# UNITED STATES PATENT AND TRADEMARK OFFICE

## Office Action Summary

10/661,287

- 1) ☐ Responsive to communication(s) filed on 13 September 2004.
- 2a) ☒ This action is **FINAL**. 2b) ☐ This action is non-final.
- 3) ☐ Since this application is in condition for allowance except for formal matters, prosecution as to the merits is closed in accordance with the practice under *Ex parte Quayle*, 1935 C.D. 11, 453 O.G. 213.

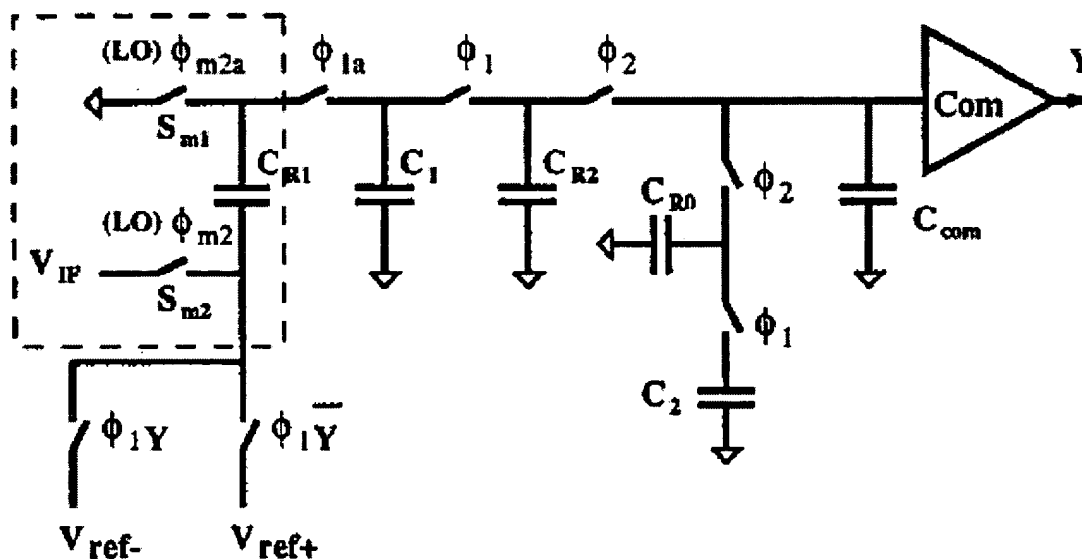
Applicant's arguments filed 13 September 2004 have been fully considered but they are not persuasive. Whether the present applicant is the author of the cited (and applied) Chen article is not particularly relevant. The examiner had assumed that it was someone different because surely applicant has cited relevant art of which he/she is aware. Beyond this the response comments to the examiner's clairvoyance. Ahh, if it were so. In reality Benabe's discloses a passive continuous time delta sigma converter that has passive continuous time forward path filter depicted in figure 3. The Chen article provides in figure 2:

It is also rather interesting that the element  $C_{R2}$  and the two switches clocked on  $\Phi_1$  and  $\Phi_2$  simulate a resistor as well known in switched capacitor technology. Capacitor  $C_{R0}$  and its two closest switches function likewise. The choice of subscripts for these two capacitors supports this reading. If one were to redraw the Chen article figure 2 circuit replacing the capacitors  $C_{R2}$ ,  $C_{R0}$  and the adjacent switches one pretty much gets a single line figure 2 of the present application. And with no clairvoyance required. Accordingly the rejection will be maintained.
